Y.M. GOOSANDER

AMENDMENTS

SEPT. 1972.

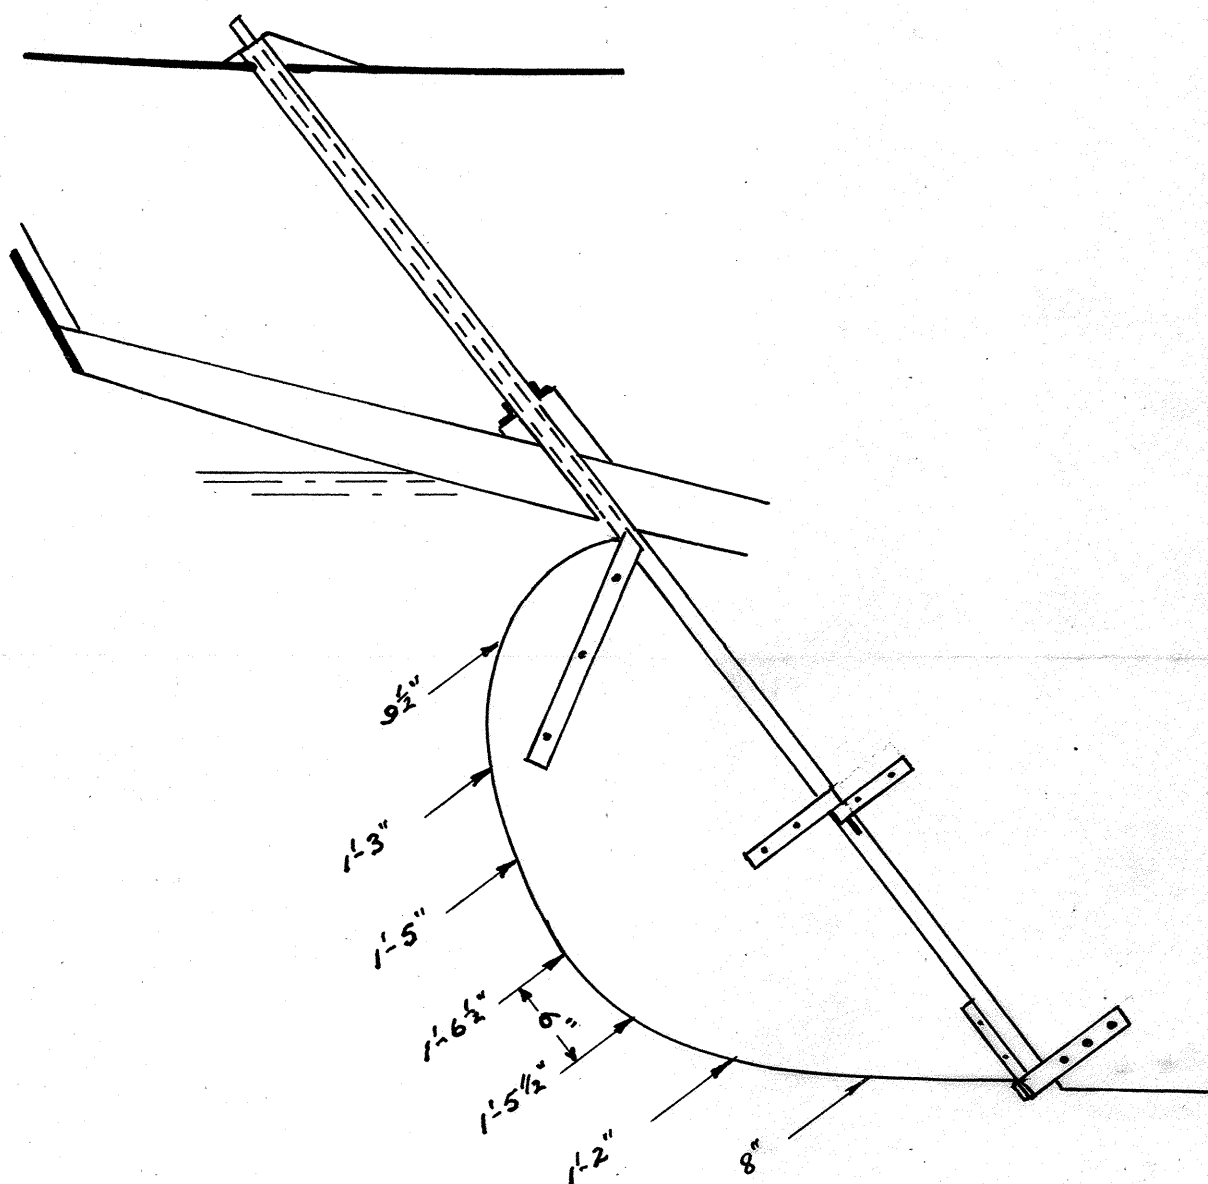
AMENDMENT TO BOLT CENTRES

1. Rudder modification where the 'Vire' Engine or a propeller of similar size is used and fitted as a centreline installation.
2. Mainsail to be reduced by 1'-6" along the foot, luff unaltered. Boom reduced in length by 1'-0"
3. Fore hatch to be moved aft on to forward end of coach roof, to provide better access.
4. Tiller to be lengthened by 7"
5. Crosstrees to be lowered 2'-6" for improved stressing.
6. Footwell to be narrowed by 3" each side to improve quarter berth width below.
7. Settee berths to be lowered 2" to allow for the use of foam mattress without reducing headroom.
